## Issue with BAsT/BGS Proposal for Sensing Width

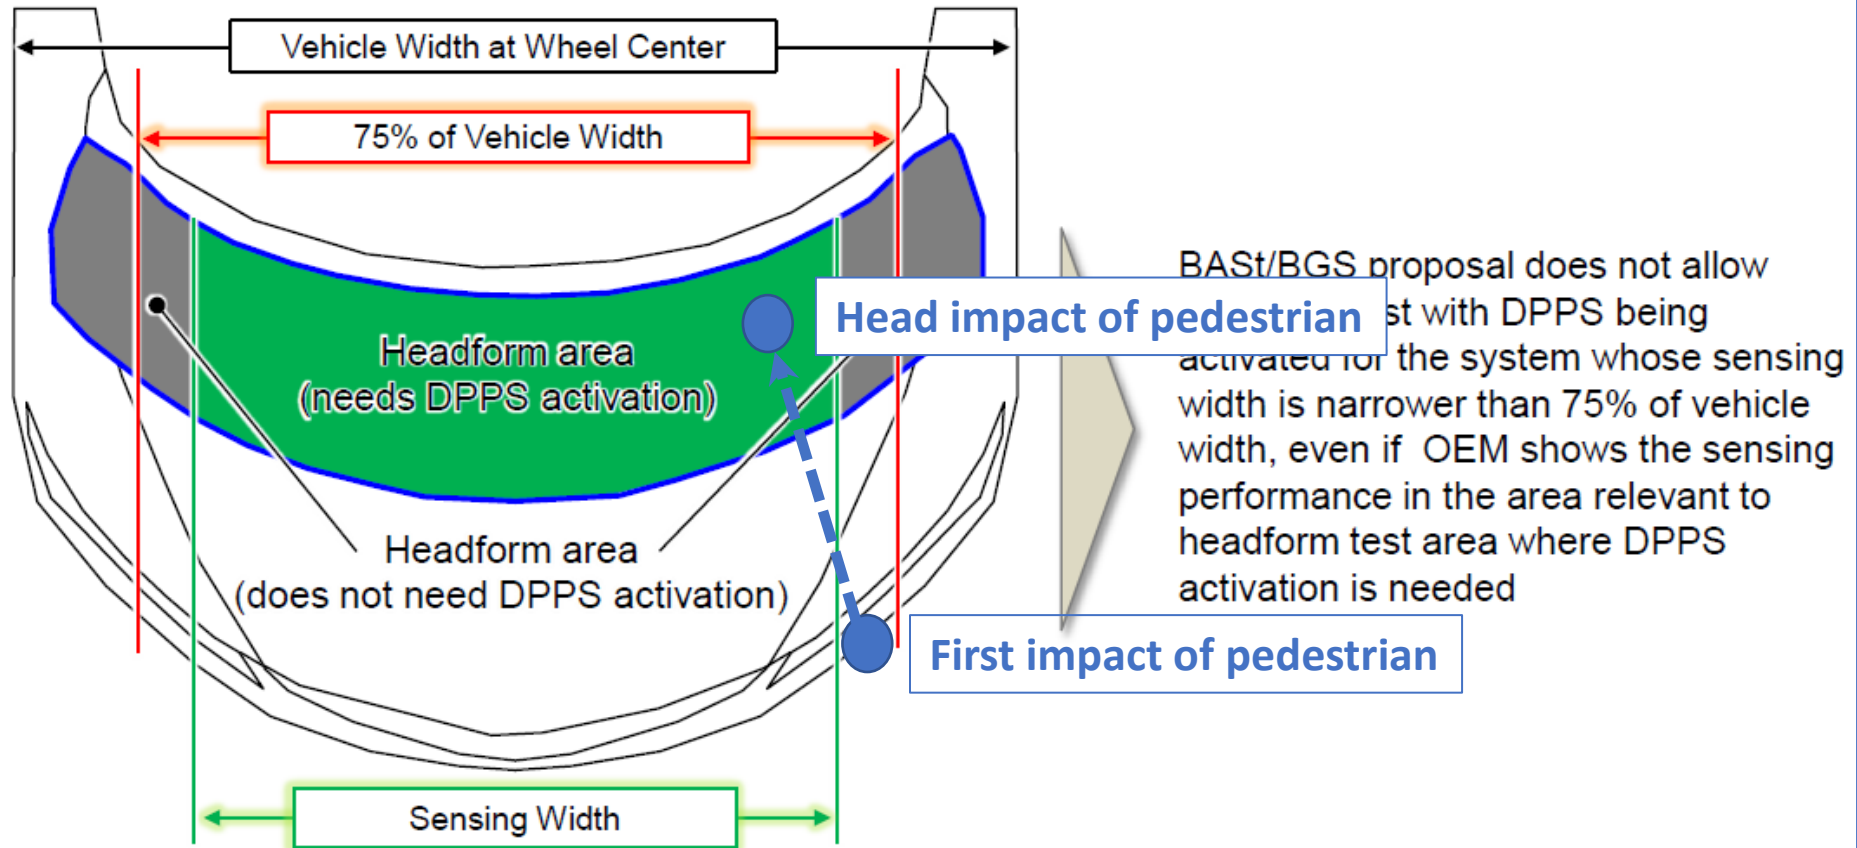
**Headform tests should be conducted with DPPS being activated in the headform test area where the detection performance is clarified**

Proposal defined in IWG-DPPS-9-09 does not account for real life accident scenarios. In many times, the pedestrian trajectory is not parallel to vehicle longitudinal vertical centreplane. A width of the detection area related to the vehicle width should be maintained.
